UNITED STATES PATENT AND TRADEMARK OFFICE

APPLICATION NO.	FILING DATE	FIRST NAMED INVENTOR	ATTORNEY DOCKET NO.	CONFIRMATION NO.
10/627,262	07/25/2003	Hakan P.O. Larsson	03370-P0047A	7595

Office Action Summary

DETAILED ACTION

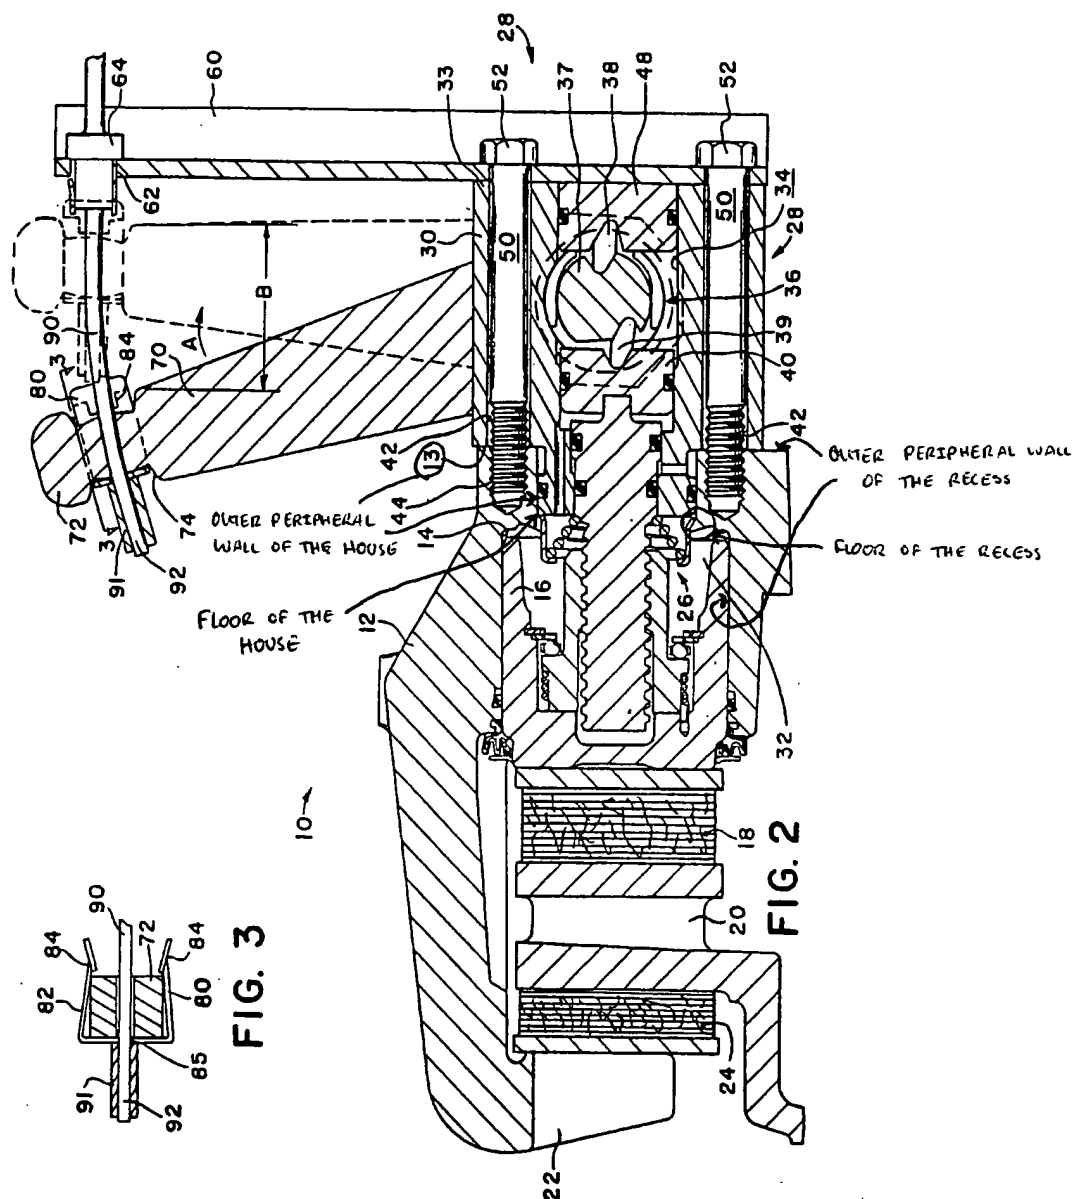
Re-claims 1 and 13, Smith et al. disclose a modular disc brake, comprising: a service brake mechanism 36 having at least one thrust unit (brake 36 is capable of acting as a service brake) and modules in the form of a frame 12, a cover 60, and a house 30 for the service brake, a part of the house is positioned between and outside the frame and the cover and mounted to be substantially unloaded during braking, see column 3 lines 18-24; the frame includes a recess defined by an outer peripheral wall (either the surface adjacent 13 or the interior surface of the

recess, which can be broadly interpreted as an outer peripheral wall with respect to the central hole volume) and a floor (the flange portion the extends inwardly from the interior surface the recess, see attached figure), the floor has a hole for the thrust unit; the house comprises an outer peripheral wall (either 13 or the outer surface of the inserted portion of the house in the recess) and a floor (the base of the inserted portion of the house that is in the recess), the floor has a hole for the thrust unit; the outer peripheral wall of the house corresponds in size and shape to the outer peripheral wall of the recess, the house is disposed in the recess in the frame such that the floor of the house abuts the floor of the recess, the holes of the recess and the house are aligned and allow the thrust unit to pass therethrough.
